Annual Monitoring Report

Monitoring Year 6 of 7

Pee Dee Stream Restoration Project
NCDMS Contract No.: 004644
NCDMS Project No.: 95350
USACE Action ID: SAW-2012-01077
DWR #: 13-1140

RE: Pee Dee Stream Restoration Site: MY6 Monitoring Report (NCDMS ID 95350)

Figure 2

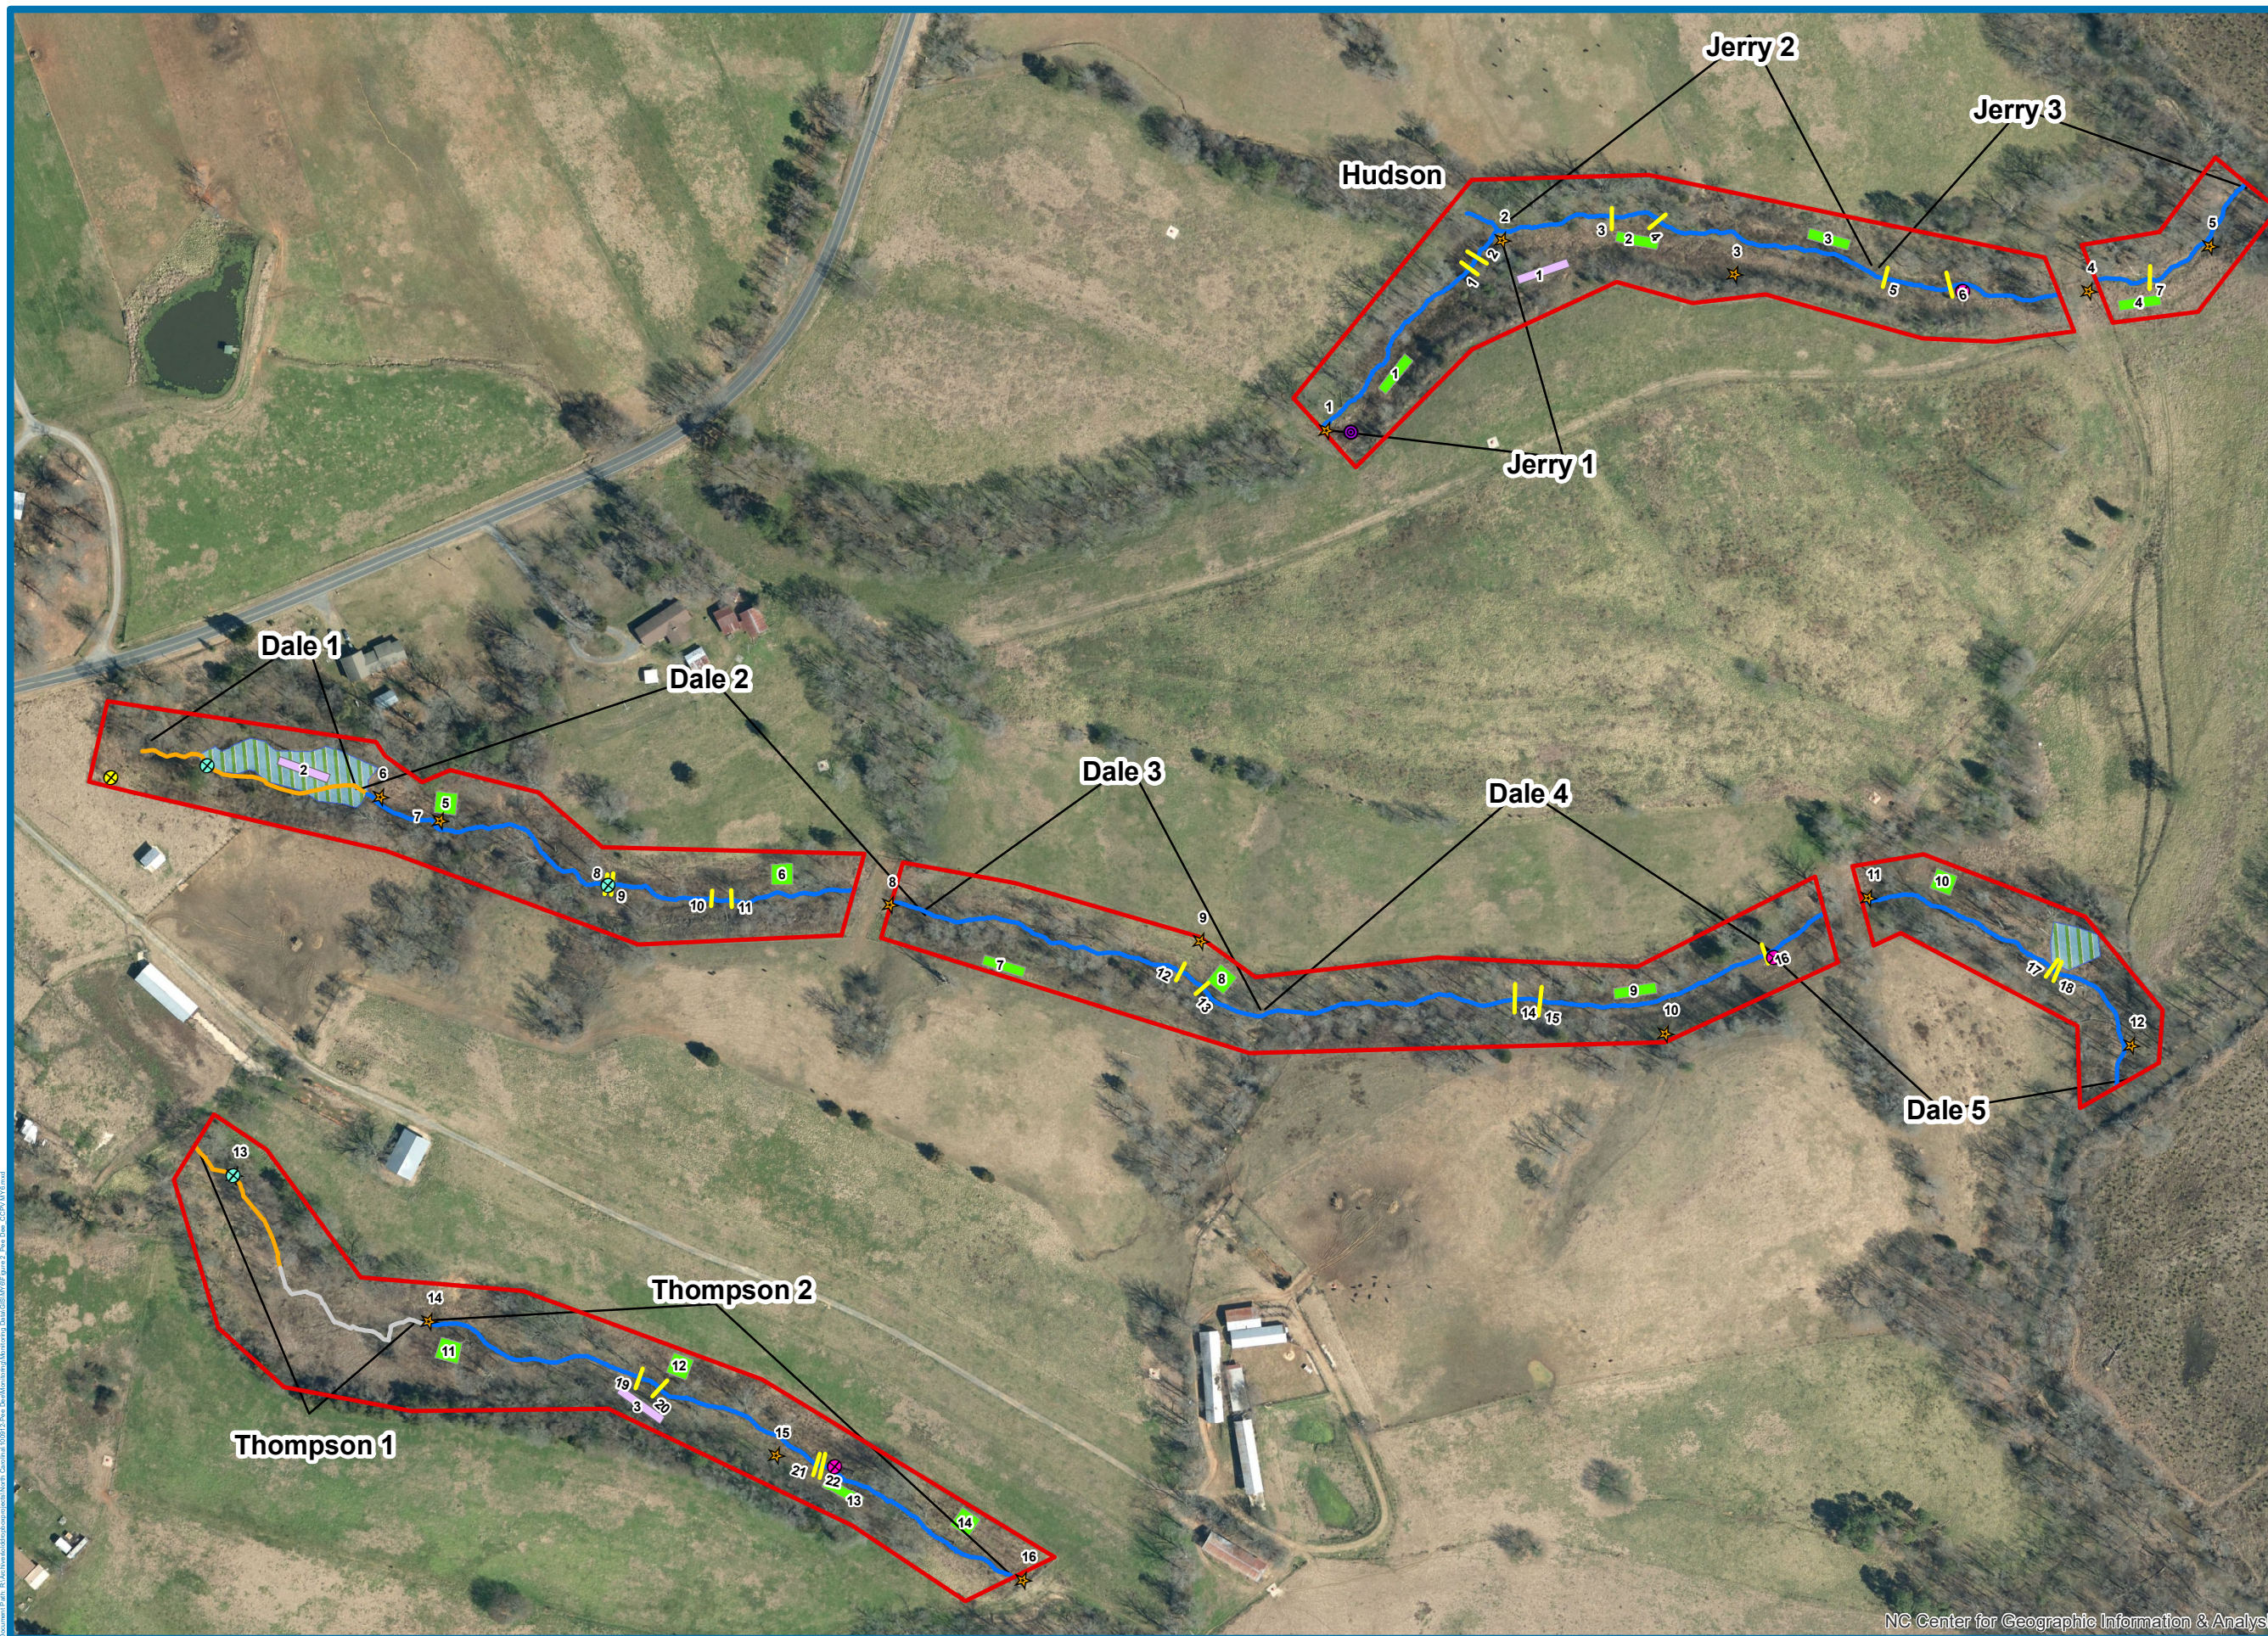
Please spatially depict the aggradation that was documented in the stream visual assessment table in the CCPV and submit these spatial features.

[The aggradation is symbolized on the CCPV as the “No Credit” reach of Thompson 1.](#)

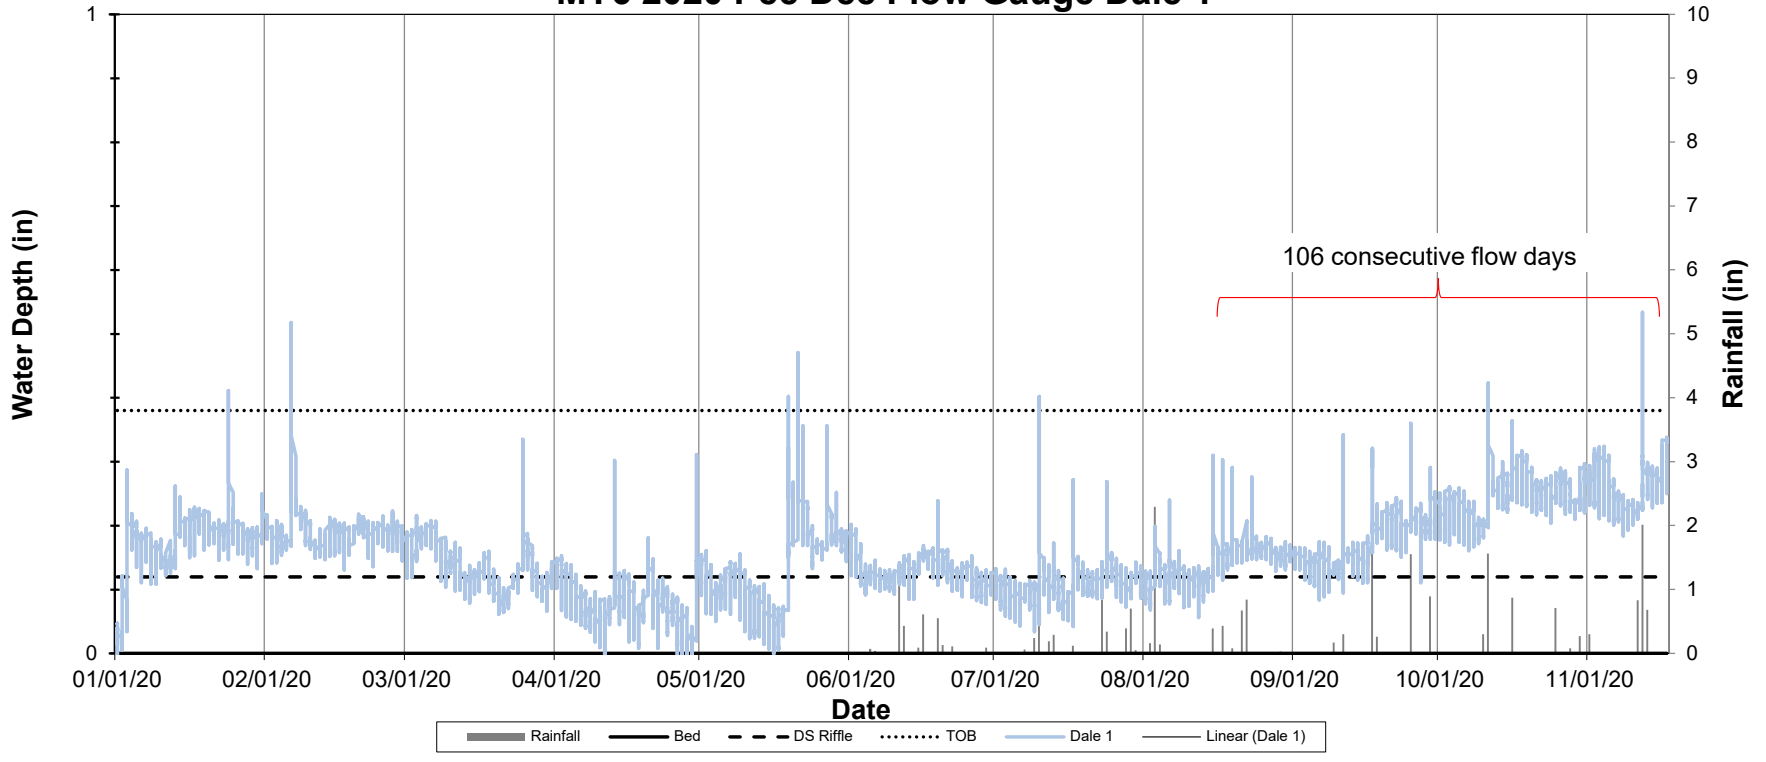
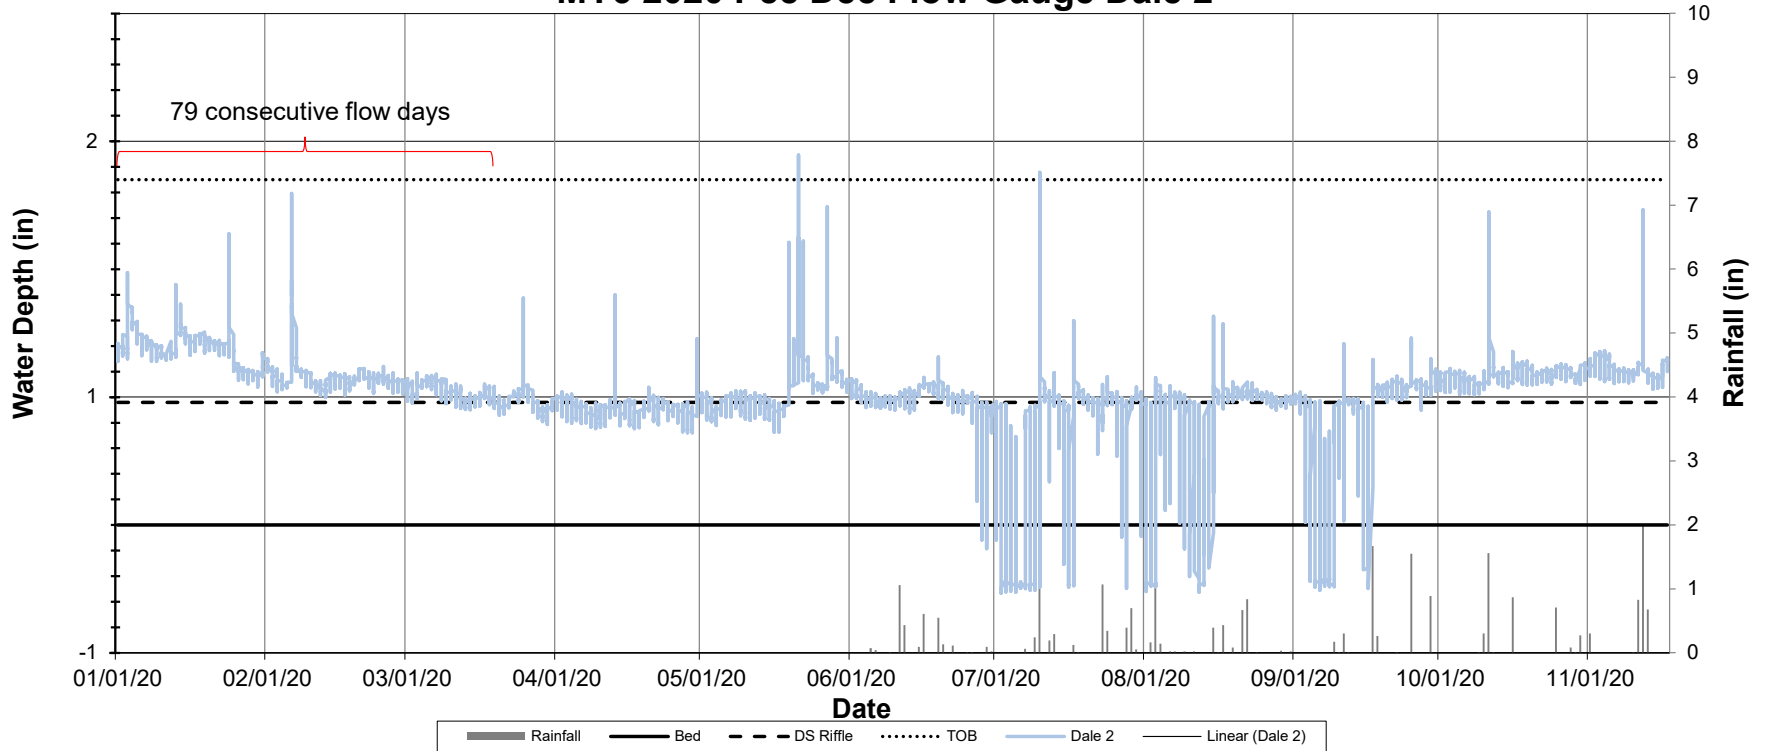
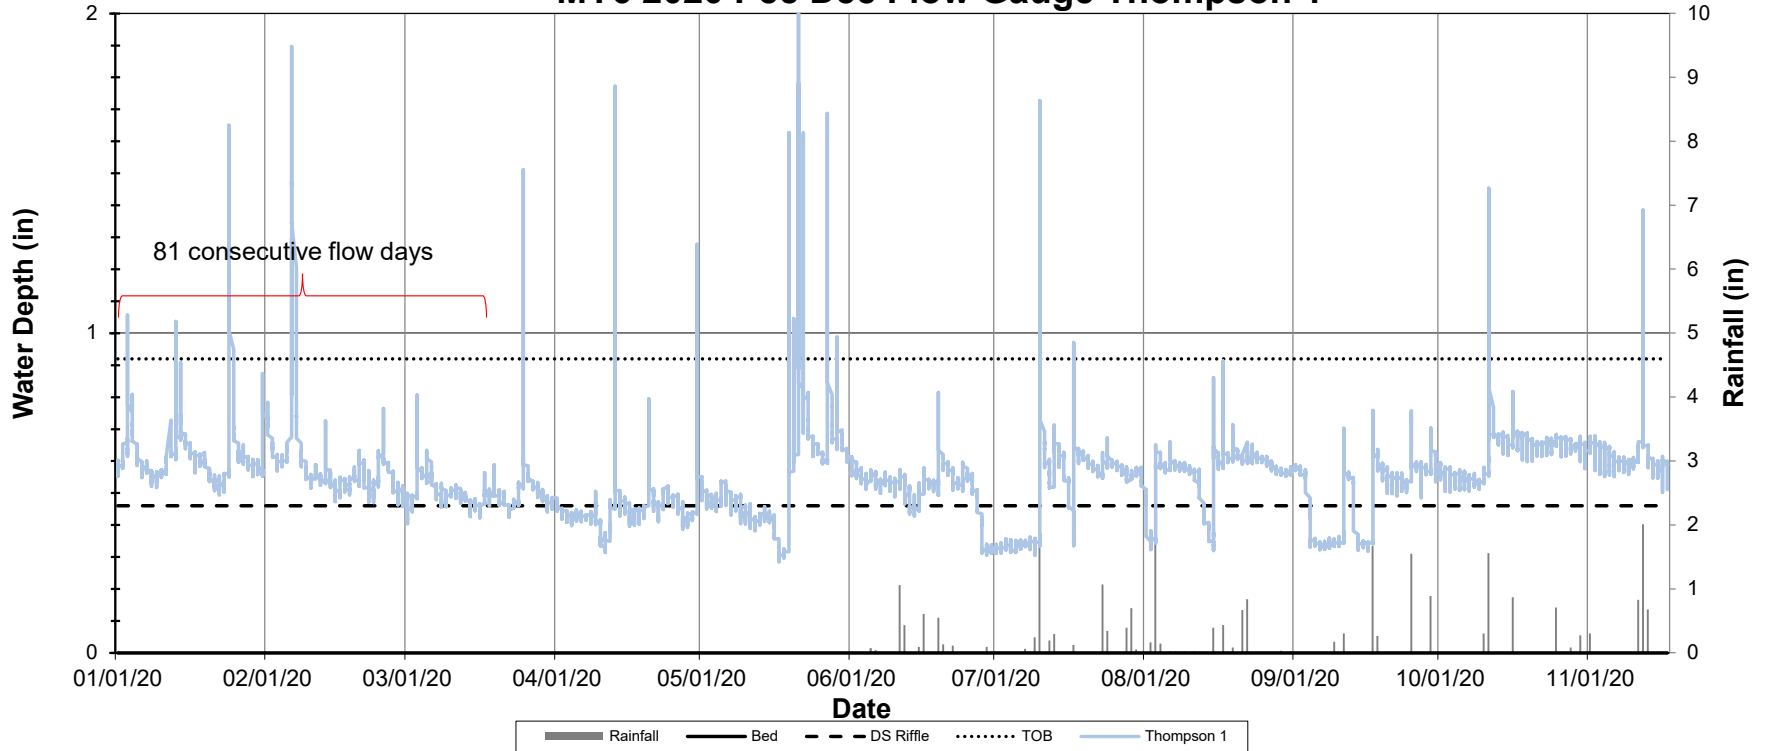
Please use text callouts to show the days of consecutive flow sections on the three continuous flow graphs

[Done.](#)
